**City of Woodinville
SR 202 Widening and Trestle Replacement Project
Project No. PW ST-13-002
Federal Aid No. HLP-0202(066)
TIB Project No. 8-1-198(006)-1**

**ADDENDUM No. 1
dated
July 22, 2026
to
Contract Documents and Plans**

DATE: 6/16/2026	CHECKED BY: RL
DESIGNED BY: UD	PROJECT NO.: ST-13-002
DRAWN BY: UD	SCALE: AS SHOWN
SHEET 142 OF 172	DRAWING NO.: BR08

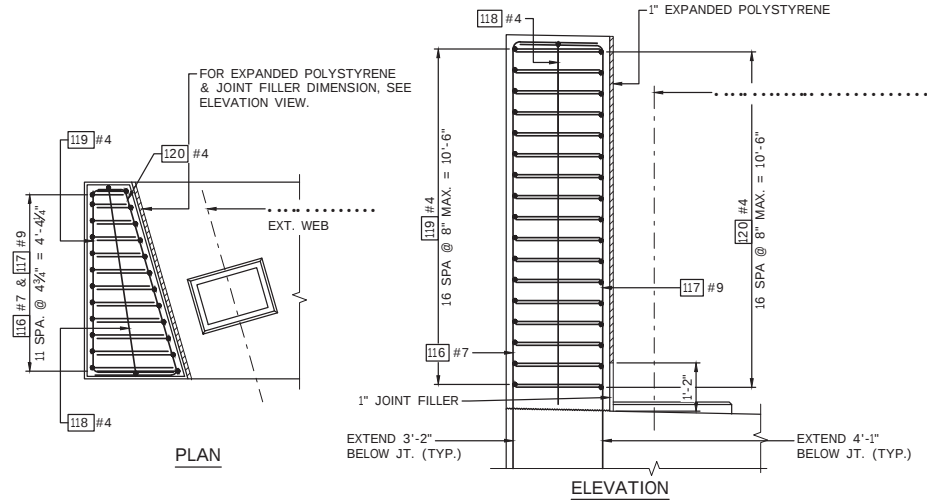
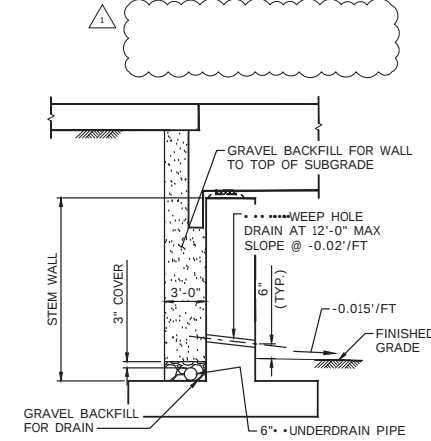
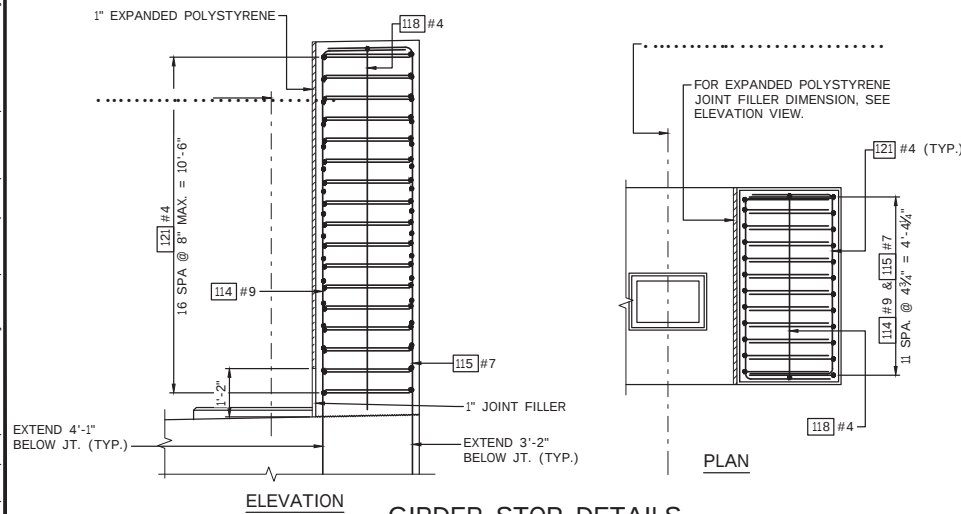
- 2.) **Plan Sheet 142, Drawing No. BR08 and Plan Sheet 145, Drawing No. BR11:** Note at the top

right of these sheets were removed.

NO.	REVISION	DATE	BY	CK
1	ADDENDUM 1 - REMOVED NOTE	7/14/26	DCH	RL

DATE: 6/16/2026	CHECKED BY: RL
DESIGNED BY: UD	PROJECT NO.: ST-13-002
DRAWN BY: UD	SCALE: AS SHOWN
SHEET 145	OF 172
DRAWING NO.:	BR11

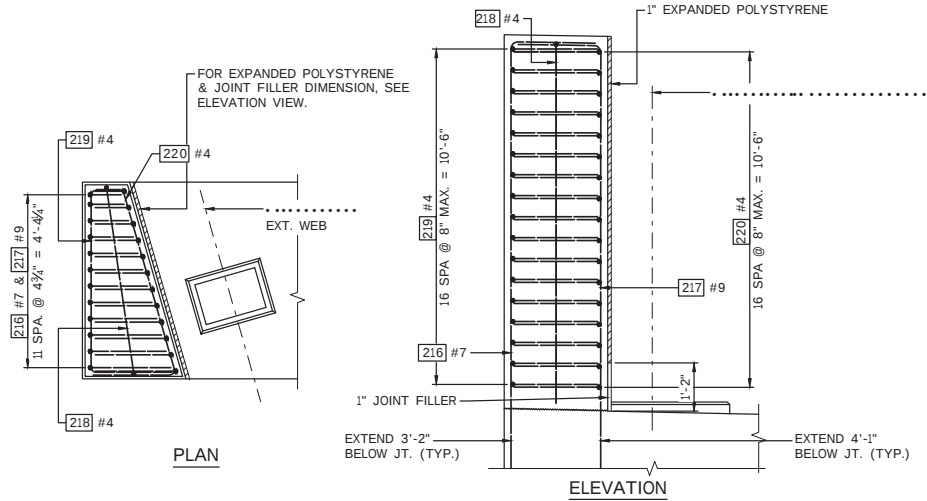
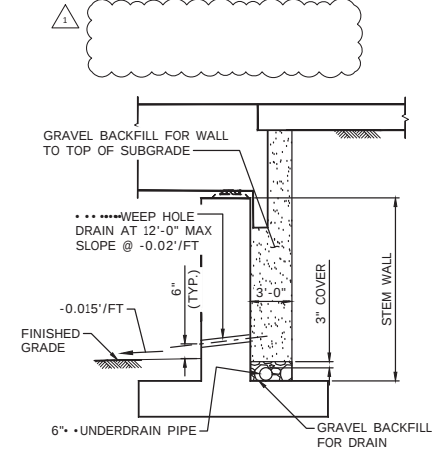
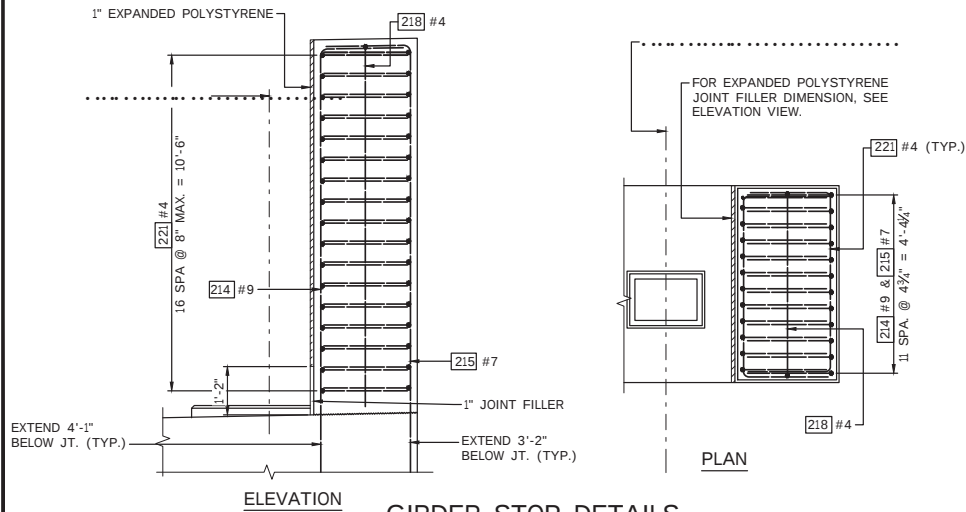
NO.	REVISION	DATE	BY	CK
1	ADDENDUM 1 - REMOVED NOTE	7/14/26	DCH	RL

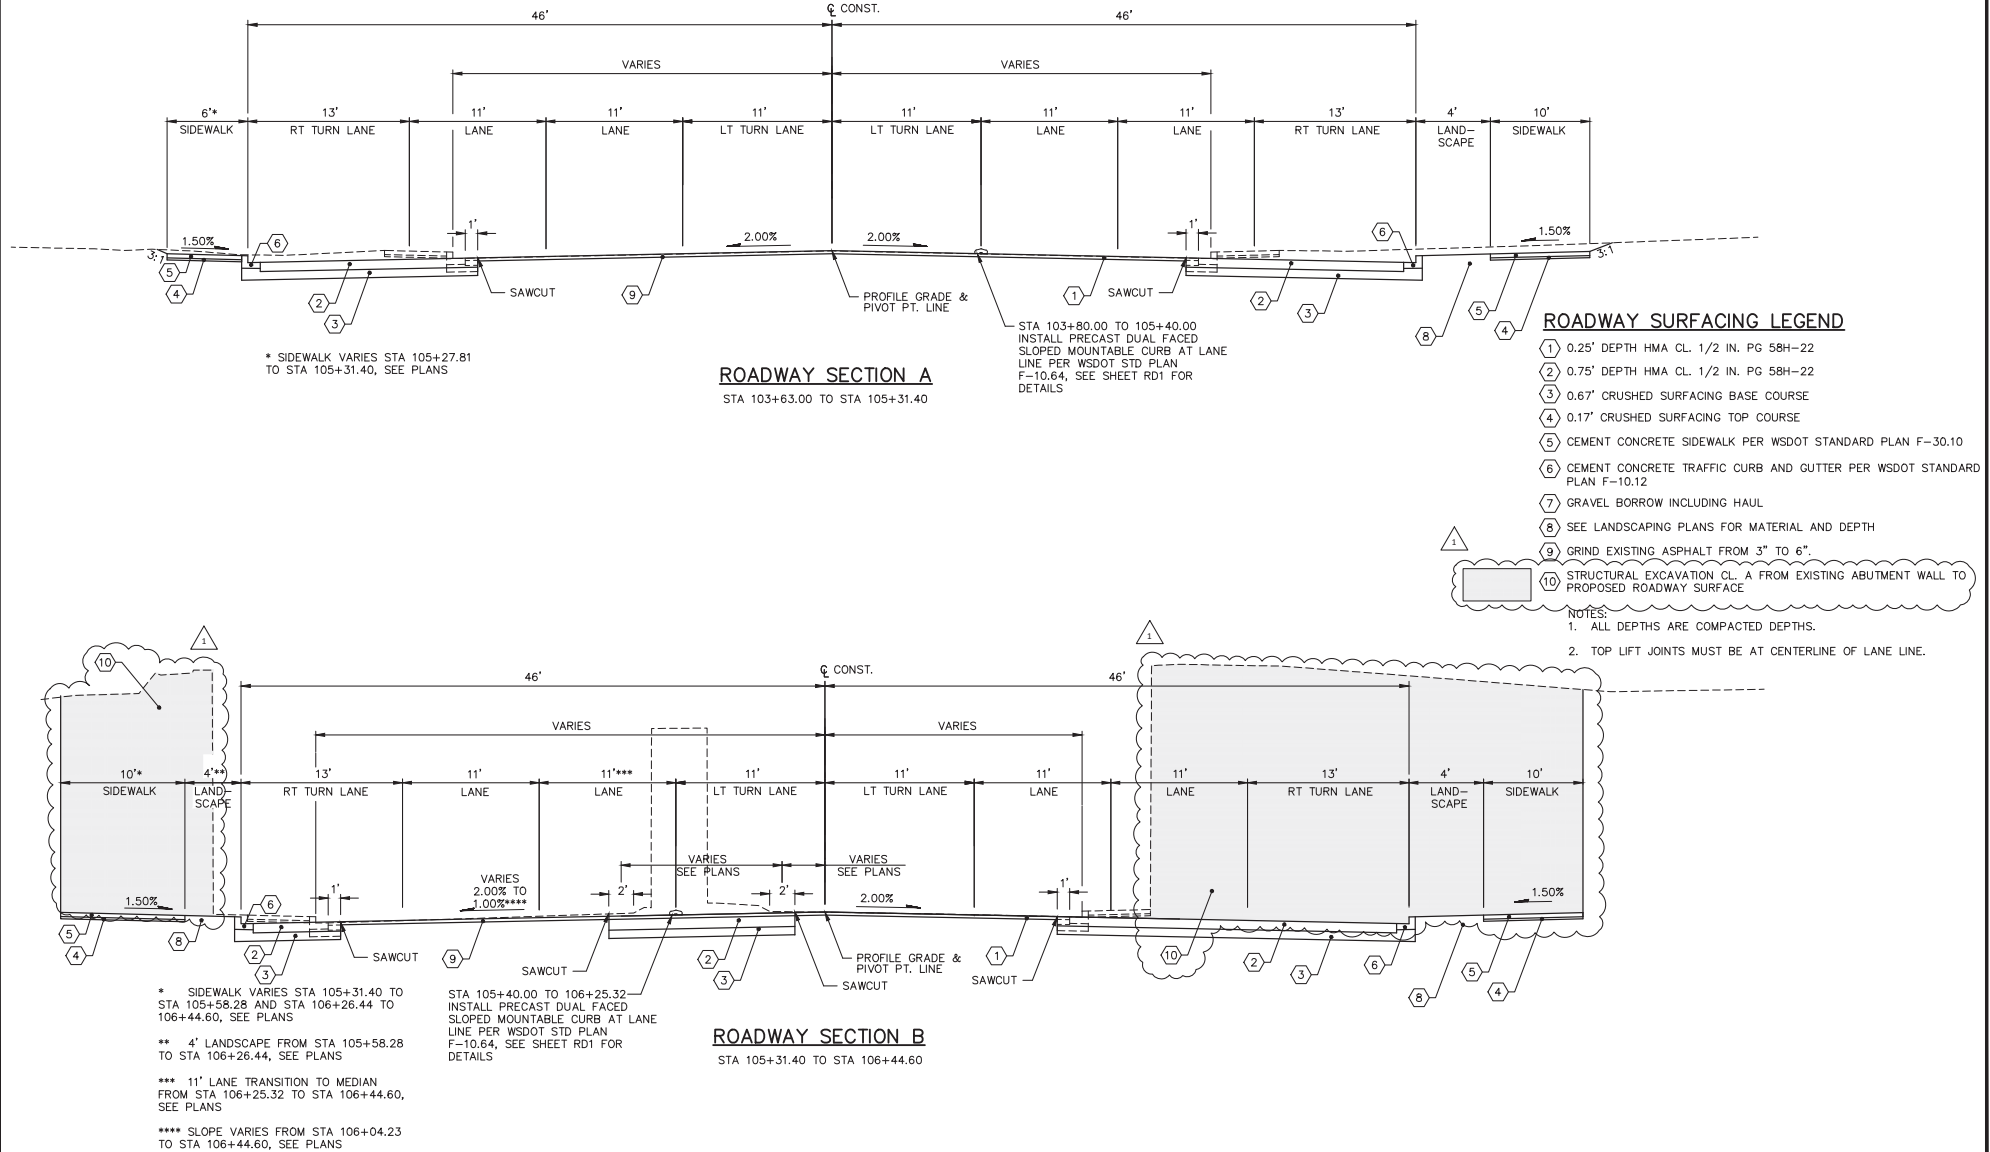
- 3.) **Plan Sheet 4, Drawing No. RS1:** Clarification on Typical Roadway Section B to show the difference between “Roadway Excavation Incl. Haul” and “Structural Excavation Cl. A”.

PROJECT INFORMATION		SHEET TITLE:	
DATE: 6/16/2026	CHECKED BY: RM	SANITARY SEWER PLAN AND PROFILE	
DESIGNED BY: BM	PROJECT NO: ST-13-002		
DRAWN BY: BM	SCALE: AS SHOWN		
SHEET 24 OF 172			
DRAWING NO: SS1

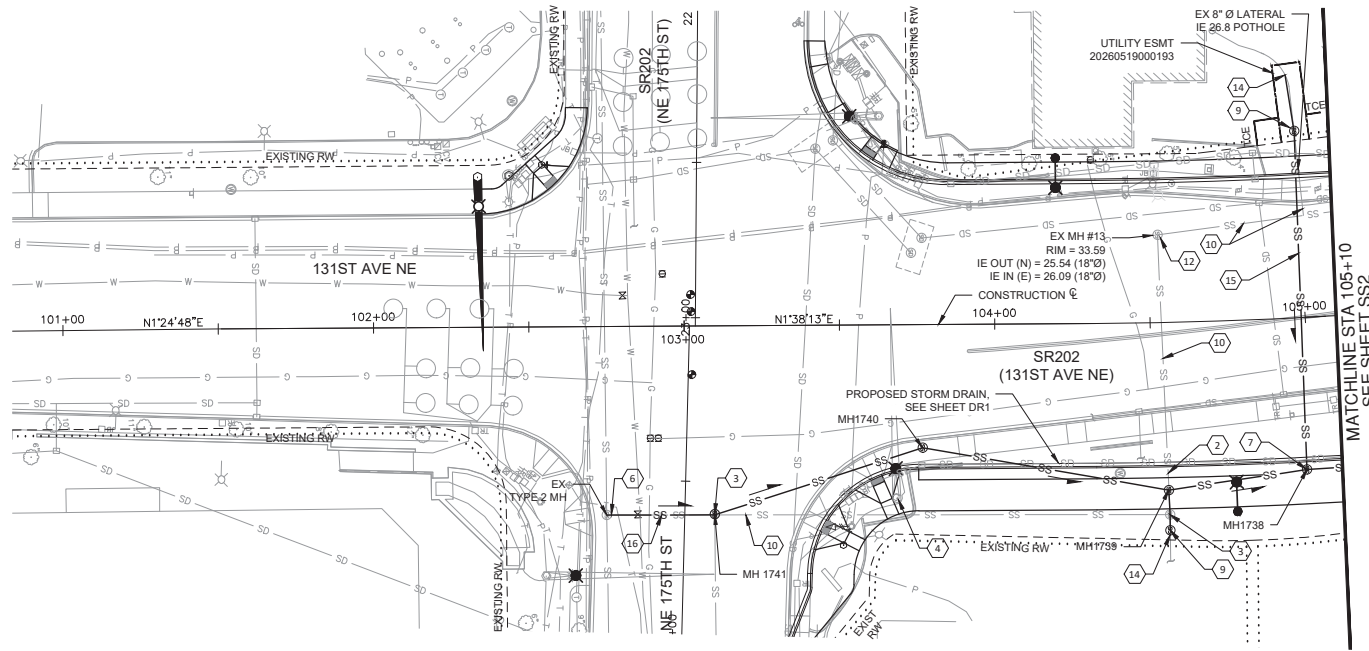
- 5.) **Plan Sheet 24, Drawing No. SS1:** Revised Construction Note 9 to add an approved equal to Ductile Iron Cl. 52 (Protecto).

- INSTALL INSIDE DROP MANHOLE CONNECTION PER WOODINVILLE WATER DISTRICT SEWER STD PLAN #7
- NOT USED
- INSTALL CLEANOUT PER WOODINVILLE WATER DISTRICT SEWER STD PLANS #14, #24, AND #24A. WYE AND CLEANOUT RISER PIPING AND APPURTENANCES TO BE 8" DIAM DI CL 52 (PROTECTO 401) OR (PERMOX-CIF, CONTINGENT UPON IT BEING INSTALLED BY A MANUFACTURER CERTIFIED AND APPROVED APPLICATION)
